## Determination 2019/020

# The refusal to issue a code compliance certificate for a 16-year-old house with monolithic cladding at 7 Second Avenue, Devonport, Auckland

**Figure 1: Approximate site plan**

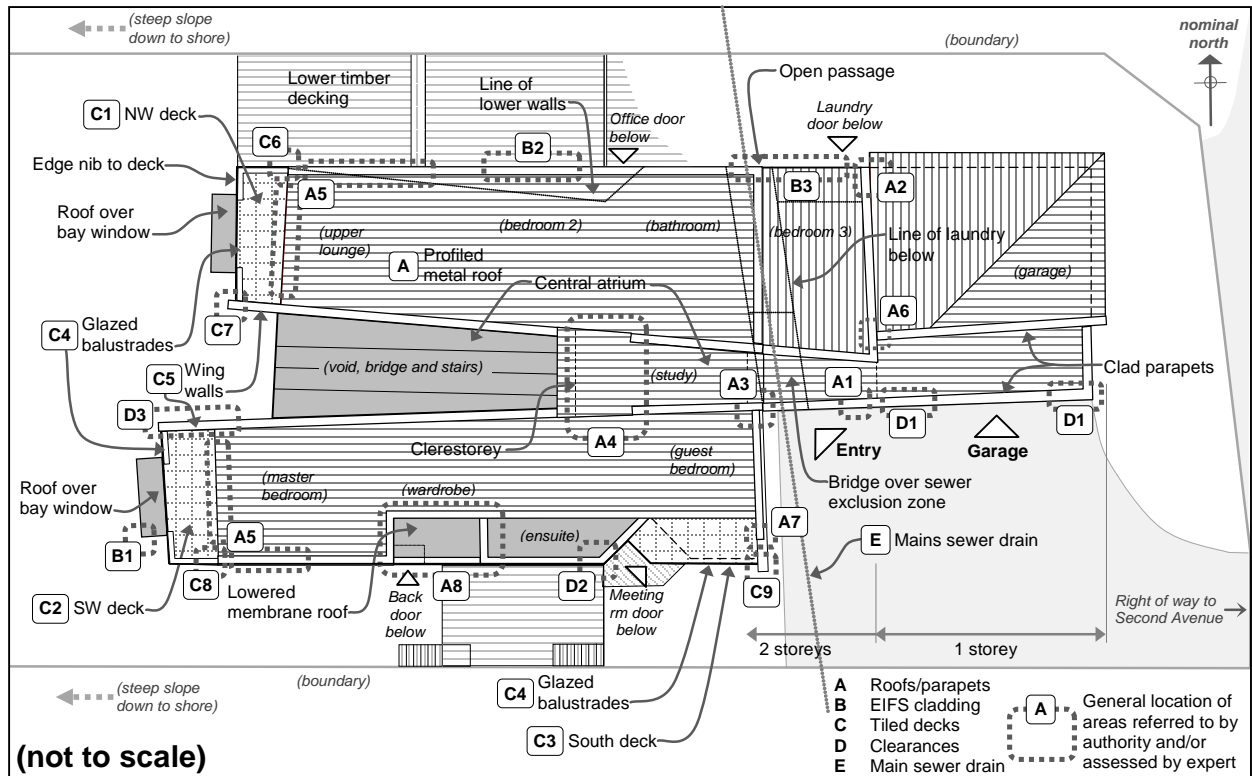
- 73% in the entry soffit framing, with 36% at the upper guest bedroom corner/atrium roof junction above the entry (Area A3)
- 29% in the east wing wall to the south deck (Area C9)
- 23% below a top-fixed baluster to the south-west deck (Area C8)
- 21% below a top-fixed baluster to the north-west deck (Area C7)
- 17% to 18% in the stepped soffit framing below bedroom 2 (Area B2)
- 16% below the vertical/sloping parapet junction in the east wing wall to the south deck (Area A7).

- In regard to the entry area (Area A3):
  - soffit linings were damp and framing had a 'highly elevated' 73% moisture level, with drillings appearing damp and partly decayed

- the parapet/roof junction directly above this soffit was poorly sealed with no upstand to the capping end. However, the source of the 73% reading is likely to stem from an apron flashing junction above this at the north-east corner of the guest bedroom where 36% moisture levels were recorded.

- In regard to the east stepped wing wall to the south deck (C3):
  - a high moisture level of 29% was recorded in framing at south-east corner below the south deck (Area C9)

- 16% was recorded below 'well sealed' junction of uncapped 30° sloped top with vertical face in south wing wall (Area A7).
- In regard to the south-east baluster to the south-west deck (Area C8):

- an elevated moisture reading of 23% was taken below the top-fixed balustrade post at the south-east corner of the south-west deck
  - slope and threshold were similar to the north deck.

- In regard to the south baluster to the north-west deck (Area C7):
  - an elevated moisture reading of 21% was taken below the south top-fixed balustrade post at the south wing wall to the north-west deck

- drill shavings were damp but otherwise there were no signs of obvious decay.
- In regard to the deck/wall junction above the family room (Area C6):
  - the family room ceiling is freshly waterstained, following heavy rain that apparently overflowed the gutter (Area A5) above onto the deck

- a section of the soffit linings had broken off, exposing heavily decayed framing and an ant nest within the building envelope
  - further investigation is needed to confirm the source of the leaking.

- In regard to the soffit framing below bedroom 2 (Area B2):
  - moisture readings of 17% to 18% were taken in the soffit overhang
  - green mould was observed around the drainage weepholes at the bottom of the EIFS cladding at the soffit step down

- in regard to the north-west and south-west corner gutters (Areas A5):
  - roofs to north and south wings drain into gutters that wrap around the north-west and south-west corners, gutters are mounted on timber fascia boards that are face-sealed to the cladding

- in regard to the rain head at the south garage/entry parapet wall (Area A1):
  - the low-pitched metal roofing drains into an internal gutter at the parapet

- a 75mm diameter outlet and 44mm diameter overflow drain from the internal gutter through the parapet and into a rain head, but the overflow is about 60mm above the main outlet pipe, and the close proximity increases the risk of both pipes being blocked

- the rain head includes a 30 x 100mm overflow slot, which is also undersized when compared against the Acceptable Solution for Clause E1, being E1/AS1

- In regard to the soffit to the wall recess to north laundry/garden area (Area B3):
  - there is a crack in the cladding at the garage eave, with many ants present although moisture recorded at only 10% (A2)

- leaking deck junctions (Areas C6, C7, C8 and C9)
- undersized internal gutter overflow (Area A1)
- cracked plaster to the EIFS cladding (Areas A2 and C6)
- inadequate ground clearances (Areas D1)
- internal barrier installation (to stairs and at study east barrier)
- inadequate smoke alarm installation.

- the top-fixed balustrades to upper decks
- cracked cladding at north garage roof/laundry recess junction (Area A2)
- lack of cavity drainage to the bottom of the EIFS cladding (Area B3)
- the lack of a drainage gap under the window sills to exposed windows
- inadequate ground clearances to the south garage wall (Area D1)
- investigation and repair in regard to moisture penetration into:
  - the ceiling below cracked EIFS at the north-west deck/wall junction (Area C6)
  - the north-west deck/wing wall junction below the top-fixed baluster (Area C7)
  - the south-west deck/wall junction below the top-fixed baluster (Area C8)

- the south-east corner below the south deck (Area C9)
- the entry recess soffit below the unsealed apron flashing (Area A3)
- the soffit framing below bedroom 2 (Area B2)
- deficiencies in the rain heads installed to parapet walls (Areas A1, A8).
